August 26, 2016
BOARD OF COUNTY COMMISSIONERS
ORANGE COUNTY, FLORIDA
Y16-7000-RM / Addendum No. 2
PARK MANOR ESTATES SECTIONS 1-8 UNDERDRAIN IMPROVEMENTS
BID OPENING DATE IS SEPTEMBER 6, 2016

PARK MANOR ESTATES SECTIONS 1-8 UNDERDRAIN IMPROVEMENTS

STANDARD ROADWAY OPEN CUT CROSS SECTION DETAIL
FINAL RESTORATION - TYPICAL OF OPEN CUTS

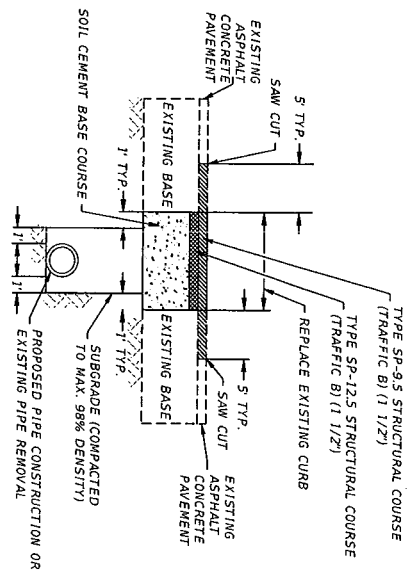
4. **Question:** The 710 TN of Superpave 9.5 asphalt, where is that to be installed? What is the square yardage for that much asphalt material?

Answer: The Superpave SP-9.5 asphalt is to be installed as the top asphalt layer for open cut restoration as shown on the Standard Roadway Open Cut Cross Section Detail on Sheet 6. As shown in the Summary of Pay Items on

Sheet 1, the quantity of Superpave 9.5 asphalt estimated for the project is 710 SY. The Schedule of Prices has been corrected to reflect that the quantity for this pay item is estimated in square yards instead of tons.

CONCRETE DRIVEWAY TYPICAL
NTS

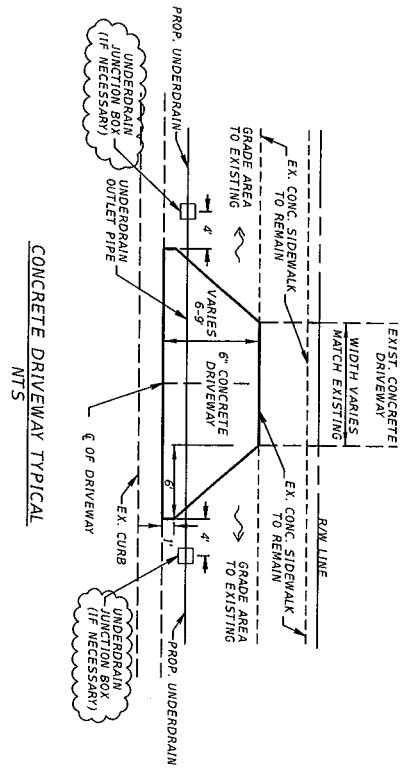
5. **Question:** Can you please provide a detail for the Underdrain Junction Boxes depicted on sheet 6 – Concrete Driveway Typical?

DATE	BY	DESCRIPTION
8/23/16	AAB	REVISED UNDERDRAIN JUNCTION BOX DRAWING NOTES.

Answer: Underdrain Junction Boxes shall be necessary only when joining dissimilar pipes that are not compatible with joining via a typical bell and spigot. In this situation, the junction box shall be provided per the pipe manufactures specifications and will require shop drawing approval prior to use. Plan sheet 6 has been revised accordingly.

5. ANY SIDEWALK TO BE REPLACED WITHIN DRIVEWAY LIMITS SHALL BE 6" THICK CONCRETE.
 6. UNDERDRAIN JUNCTION BOXES SHALL BE NECESSARY ONLY WHEN JOINING DISMANTLED PIPES THAT ARE NOT COMPATIBLE WITH JOINING AND SEALING VIA A TYPICAL BELL AND SPIGOT. IF THIS SCENARIO IS ENCOUNTERED, THE JUNCTION BOX SHALL BE PROVIDED PER THE PIPE MANUFACTURER'S SPECIFICATIONS AND WILL REQUIRE SHOP DRAWING APPROVAL PRIOR TO USE.
